Comment Letter from Los Angeles Department of Water & Power (Comment Letter #46)

Subject: Los Angeles Department of Water & Power's Comments on Draft 2016
Air Quality Management Plan

Responses to Comment Letter from Los Angeles Department of Water & Power (LADWP)
(Comment Letter #46)

Figure 1. Comparison of observed ozone (black), results of dynamic evaluation of the 2012 AQMP 2008 CMAQ database (orange), 2012 AQMP projected ozone (green) and draft 2016 AQMP projected ozone (blue) rate of change (ppb/year).

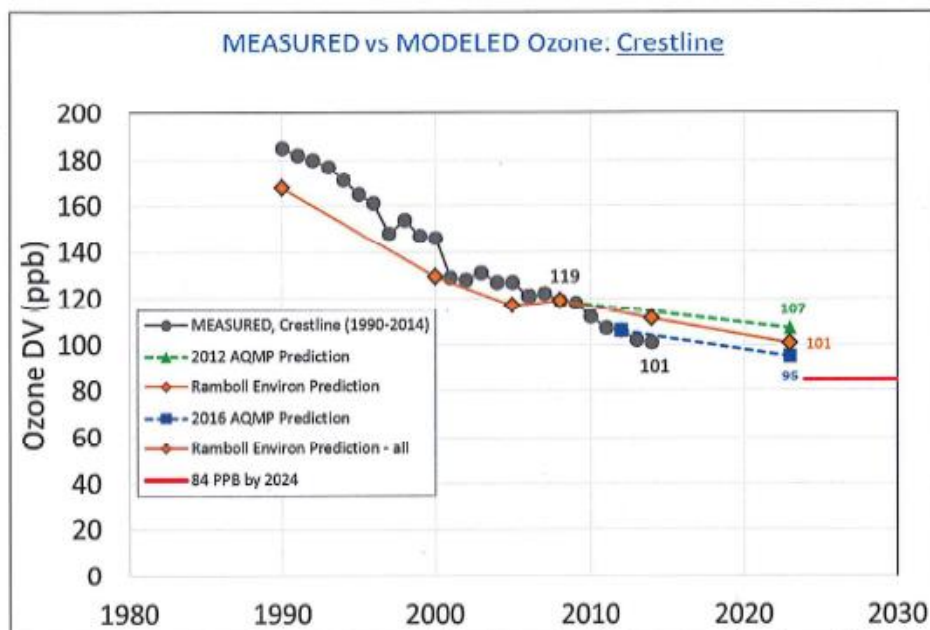
- The 2012 AQMP modeling using a 2008 CMAQ modeling database projected that the 5-year (5Y) ozone Design Value (5Y-DV⁶) at Crestline would be reduced from 116 ppb in 2008 to 107 ppb in 2023 without any additional controls for an ozone reduction rate of 0.60 ppb/year.

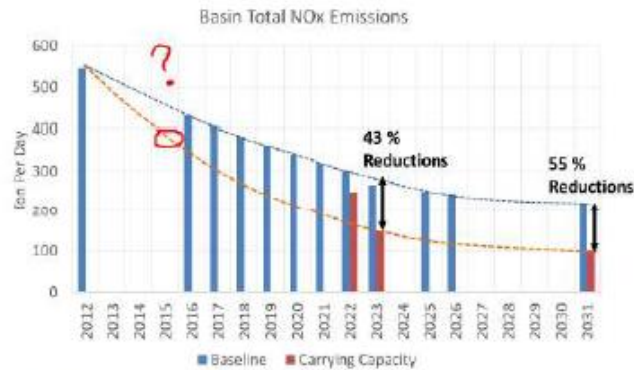
The red line in Figure 5-24 of the AQMP (reproduced below) shows the necessary “glide path” to achieve an additional 43% reduction in NO_x levels by 2023, and indicates a baseline NO_x level on the order of 390 tpd in 2015. However, that baseline number has not been achieved based on current inventories. Similarly, the expectation of a gradual decrease in NO_x (red line) between 2012 and 2023 is not realistic. Accordingly, if the targeted 43% reduction in NO_x (already overstated, as noted above) is to be achieved, it will have to take place at the tail end of the 2012-2023 time period, which would more accurately describe the emission reduction challenge suggested by the current Draft AQMP’s attainment modeling. Figure 5-24 should be revised so that the red dashed line begins in 2017 and is consistent with the emission reduction timing described in the Draft AQMP’s descriptions of the proposed control measures.

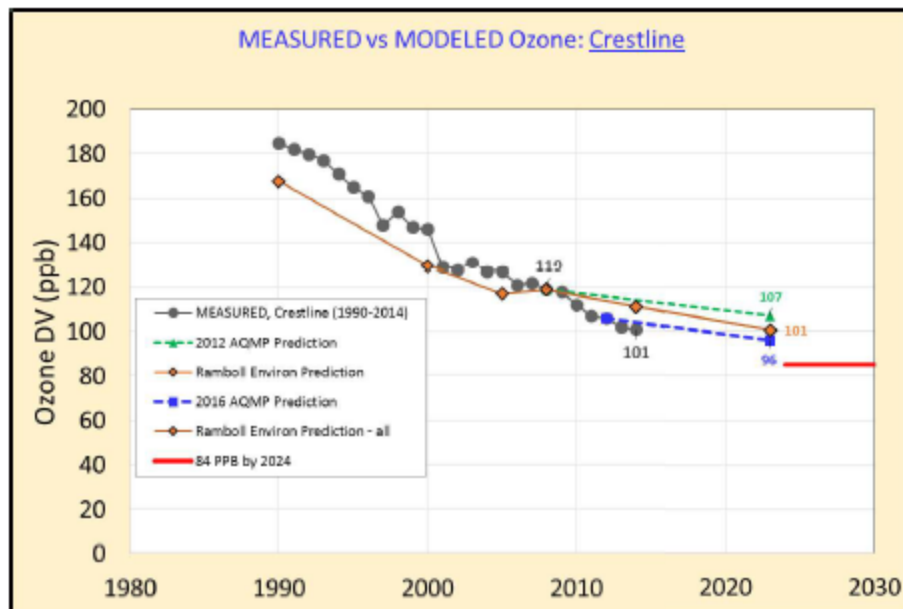
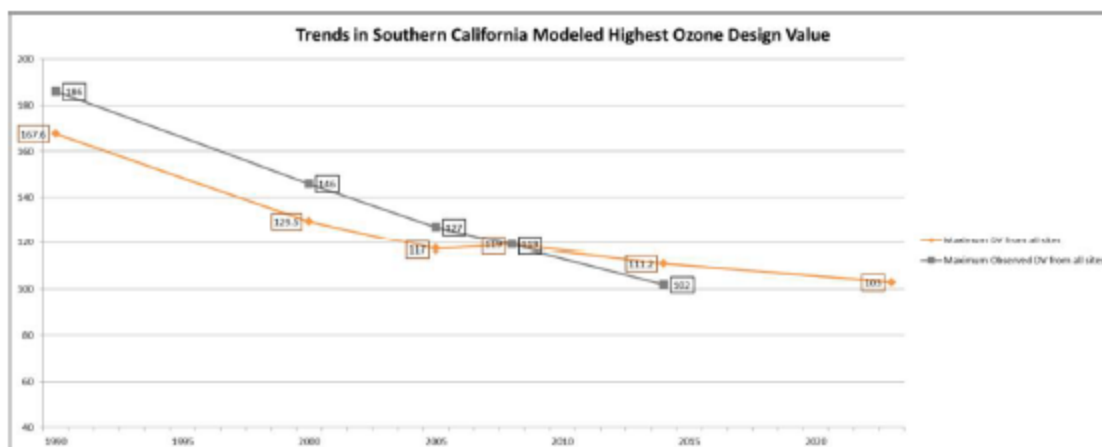
To check on the responsiveness of the CMAQ model, the Ramboll Analysis performed a “dynamic evaluation,” including “backcasts” using CMAQ, and modeled past ozone levels that could be directly compared on a year-to-year basis against actual monitored ozone levels. Once again, those backcasts confirmed that the CMAQ-derived trend lines were flatter and less responsive than the actual trend lines, not just with respect to forecasted ozone levels, but against past ozone levels as well. CMAQ’s lack of responsiveness is depicted in the following chart (see the orange line) for the Crestline monitoring site.

The phenomenon observed at Crestline — that both forecasted and backcasted ozone trends derived from CMAQ are flatter and less responsive than actual monitored trends—also holds at almost every other monitoring site in the SCAB. The net result is that CMAQ-modeled ozone forecasts, as developed by CARB, have been and are over-predicting future ozone levels in the SCAB. In addition, it also is clear that actual ozone levels in 2014 already were significantly lower than the ozone levels that CARB forecasted for 2023, and that the actual rates of decline in ozone levels in the SCAB (on a ppb/year basis) are greater than the CMAQ-modeled rates by a factor ranging from 2 to 8, as depicted in the following charts:
